Number: FS-2012-03

Subject: Exhaust System Flex Pipe Change

FIELD SERVICE BULLETIN

For replacement of Red Silicone (Linkeo) exhaust bellows with All Metal (Tru-Flex) exhaust bellows on 2010 Emissions year engine equipped buses

FIGURE 3. ISL-G CNG ENGINE

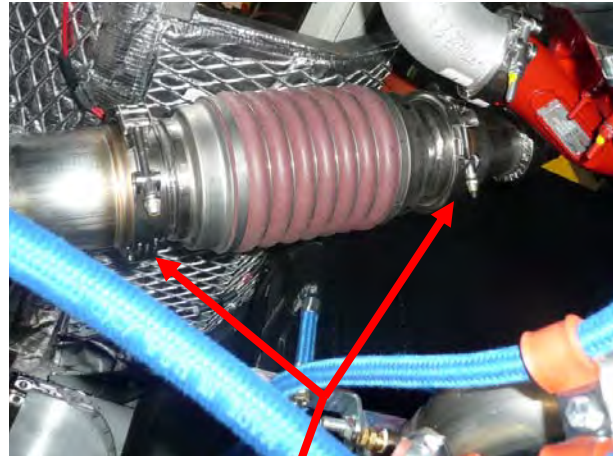
1. Remove the existing red silicone exhaust bellows from the bus by loosening the two V-Band clamps.

LOOSEN V-BAND CLAMPS SHOWN TO REMOVE THE EXISTING BELLOWS (CLAMP LOCATION "C")

FIGURE 6.

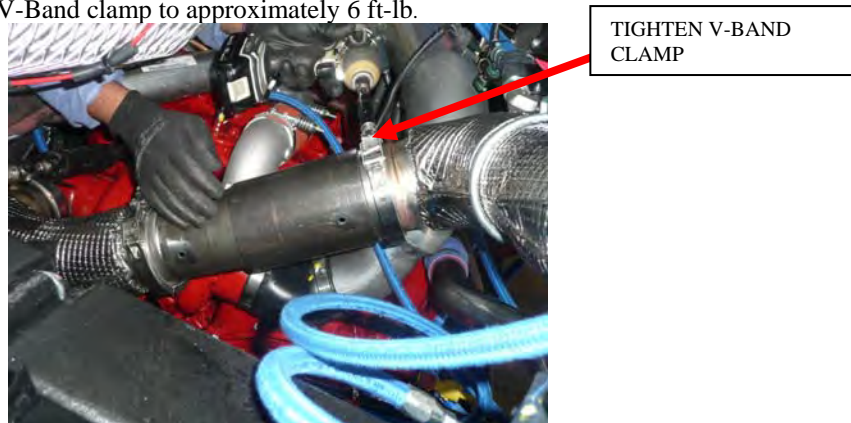
2. Insert the alignment tool between the turbo outlet pipe & muffler inlet pipe (as shown below), tighten the bottom V-Band clamp to approximately 6 ft-lb and align the other end of the tool with muffler inlet pipe. **NOTE: DO NOT FORCE THE ALIGNMENT TOOL TO FIT.**

3. Then tighten the upper V-Band clamp to approximately 6 ft-lb.

If alignment tool fits between the pipes with V-Band clamps installed to approximately 6 ft-lb, remove the alignment tool and install new all metal bellows (jump to step 9).
If alignment tool does not fit then continue to step 4.

FIGURE 7.

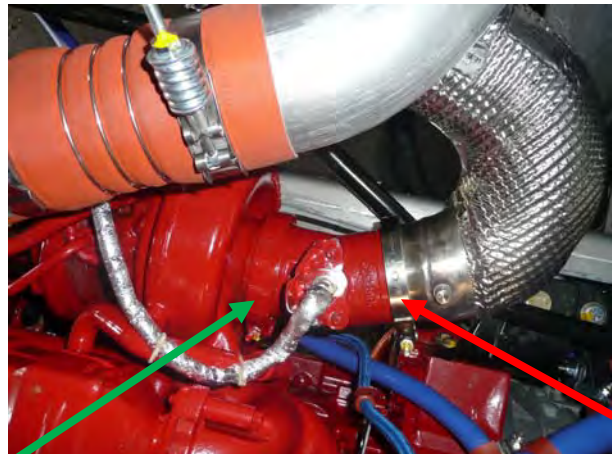
4. To access the turbo outlet pipe V-Band clamps, remove the settee hatch from inside the bus.
5. Loosen both Cummins cast turbo outlet elbow V-Band clamp and exhaust turbo outlet pipe V-Band clamp through the settee hatch access.

LOOSE V-BAND CLAMPS
THROUGH SETTEE HATCH

FIGURE 14. ISB/ISL DIESEL ENGINE SHOWN

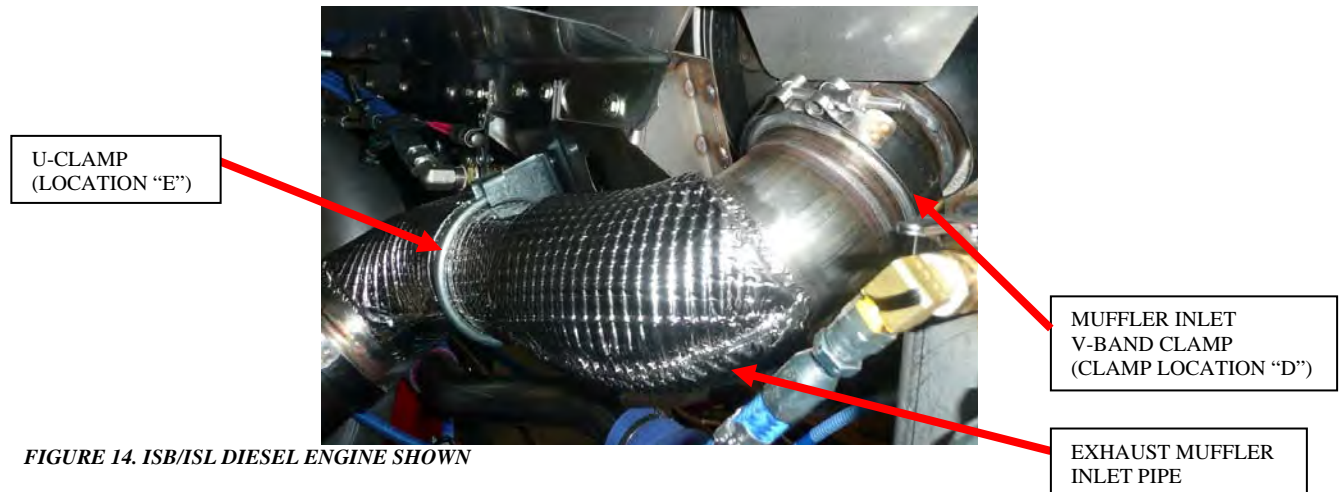
6. Loosen the V-Band & U clamps on exhaust muffler inlet pipe. Loosening the clamps will allow the pipes to move into alignment.

7. Align the pipes with alignment tool & torque all clamps to 13+/- 0.5 ft-lb in the following order:
